PROJECT TITLE: Meads Bakery Refurbish ZONE ATLAS/DRNG. FILE #: K-15/1163
DRB #: _____ EPC #: _____ WORK ORDER #: _____

**RE: REVISED DRAINAGE PLAN FOR AN ADDITION TO MEADS BAKERY
(K15-D63) REVISION DATED 11/21/96.**

DRAINAGE PLAN

A REMODEL FOR:
MEADS BAKERY
717 COAL AVE SE ALBUQUERQUE, NEW MEXICO

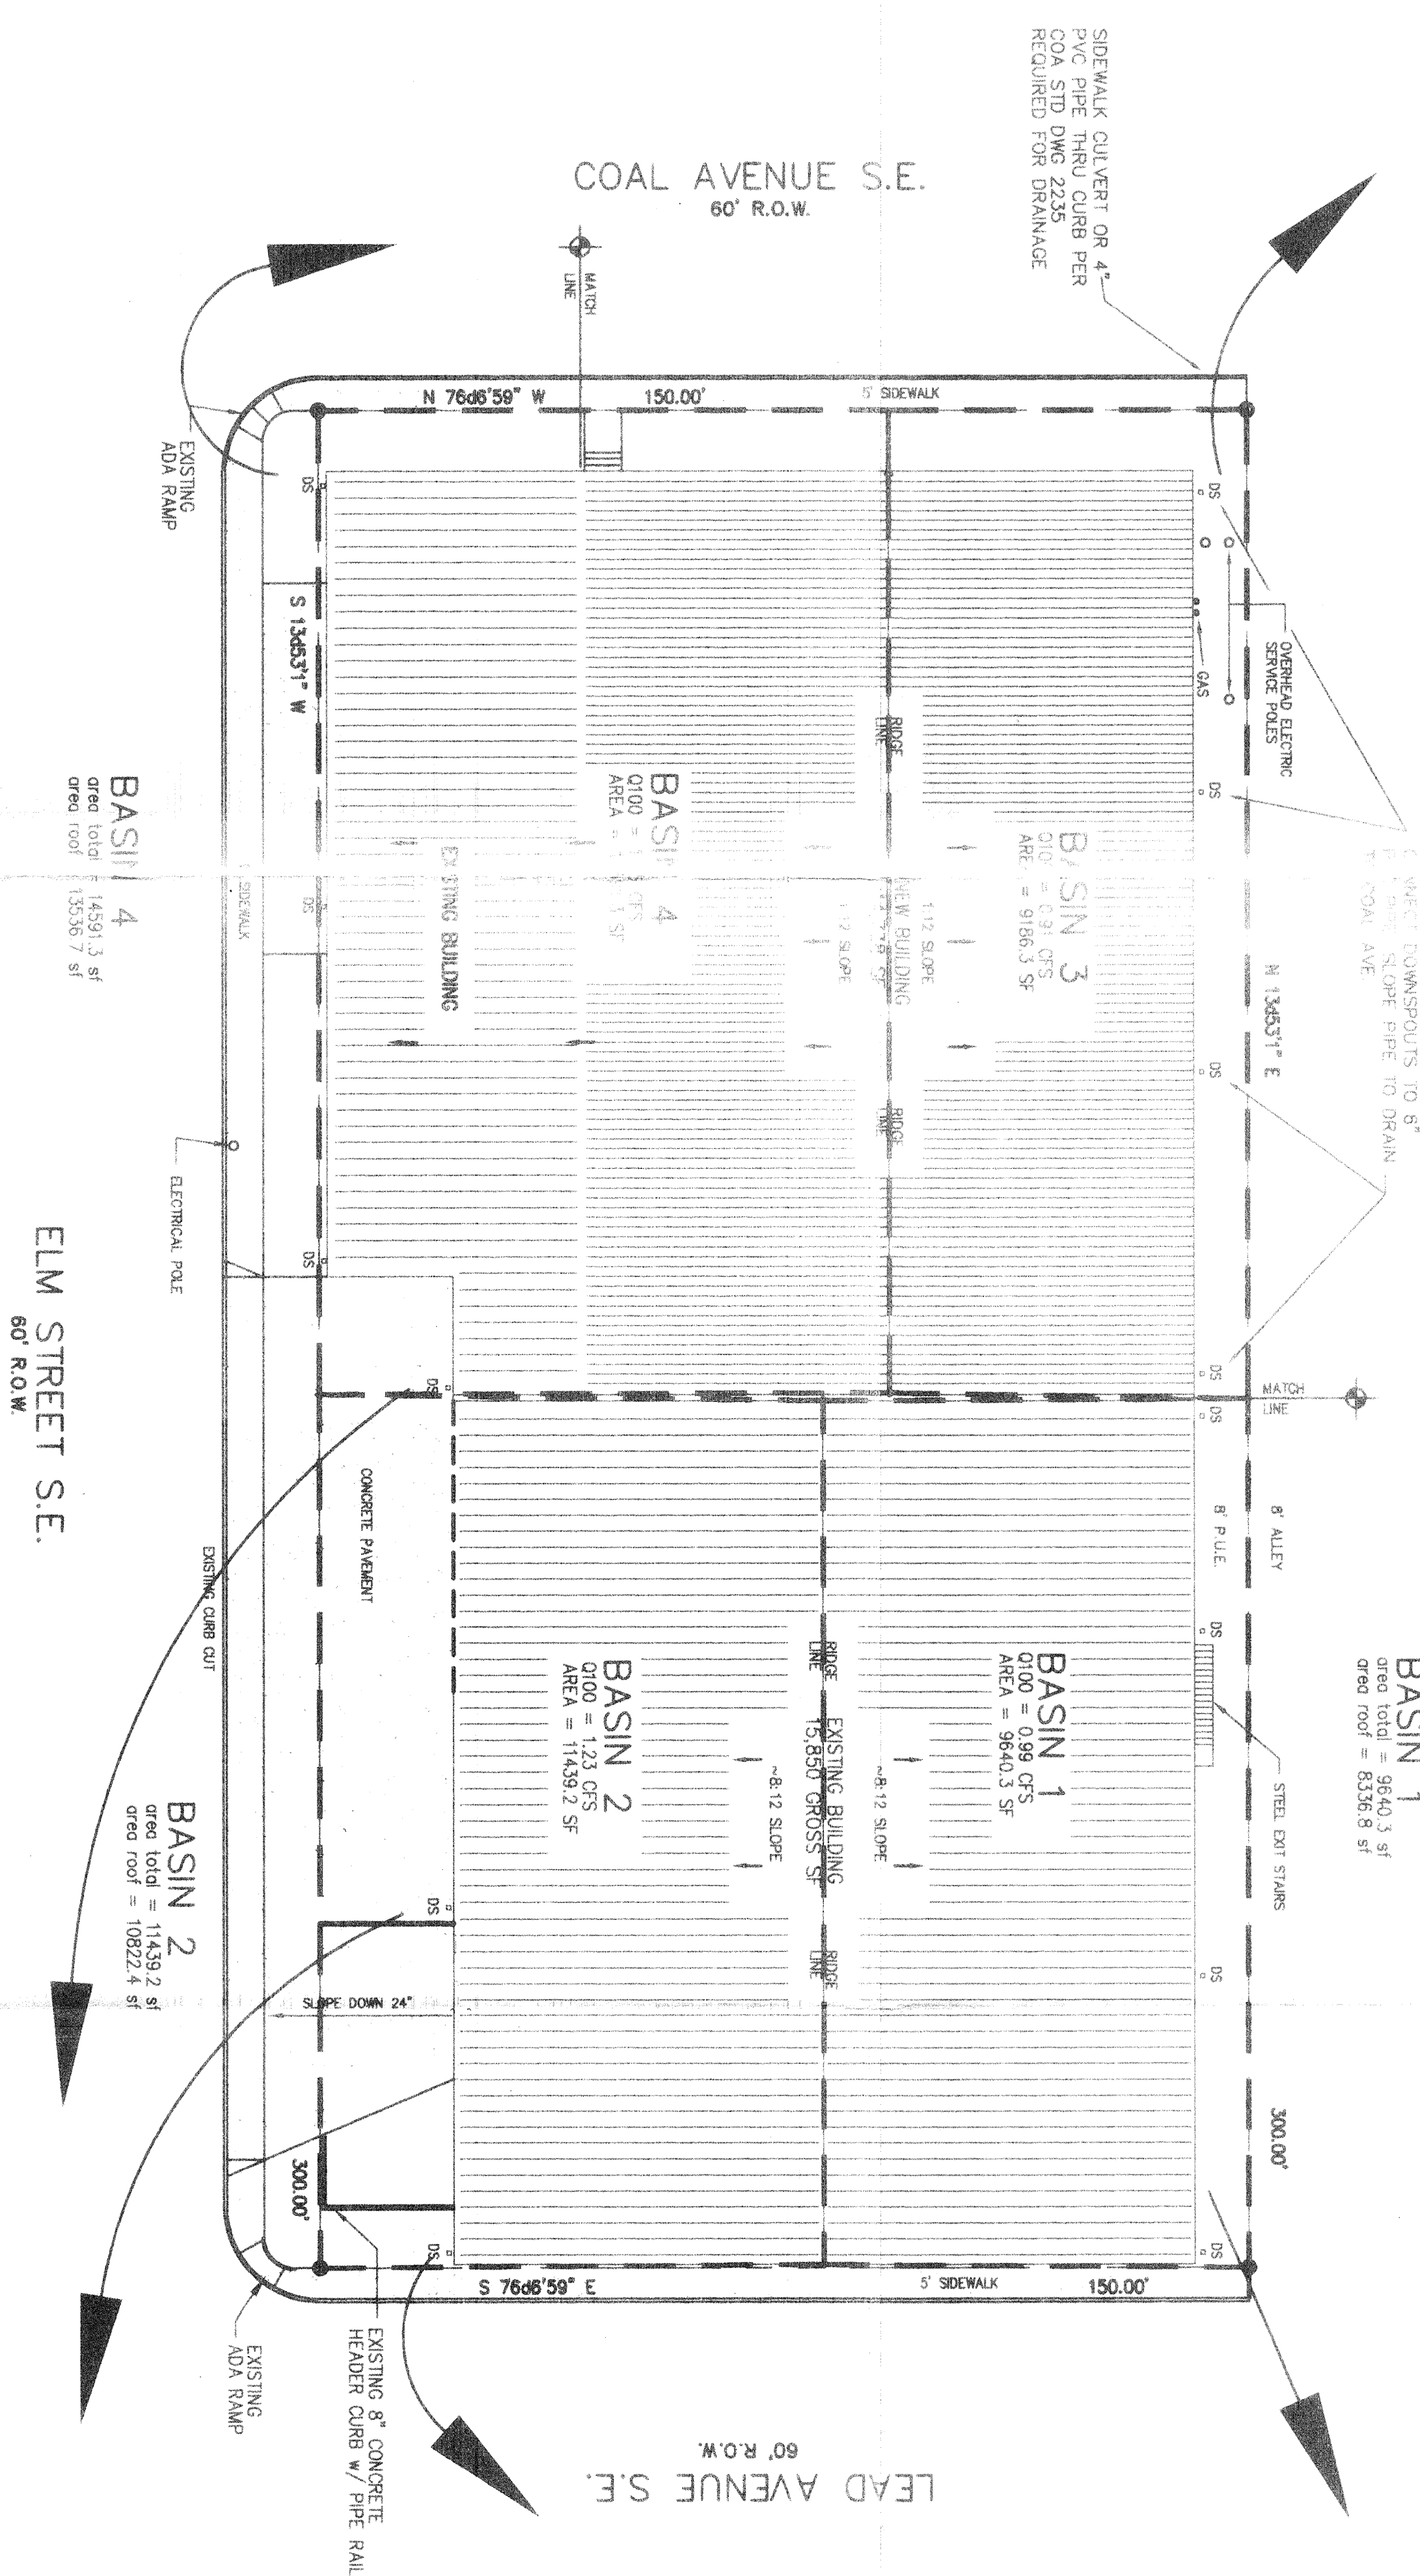
Based on the information provided on your November 20, 1996 resubmittal, the above referenced site is approved for Building Permit and S.O. 19.

Please attach a copy of this approved plan to the construction sets prior to sign-off by Hydrology.

Also, a separate permit is required for construction within City Right-of-Way. A copy of this approval letter must be on hand when applying for the excavation permit.

Prior to Certificate of Occupancy release, Engineer Certification per the D.P.M. checklist will be required.
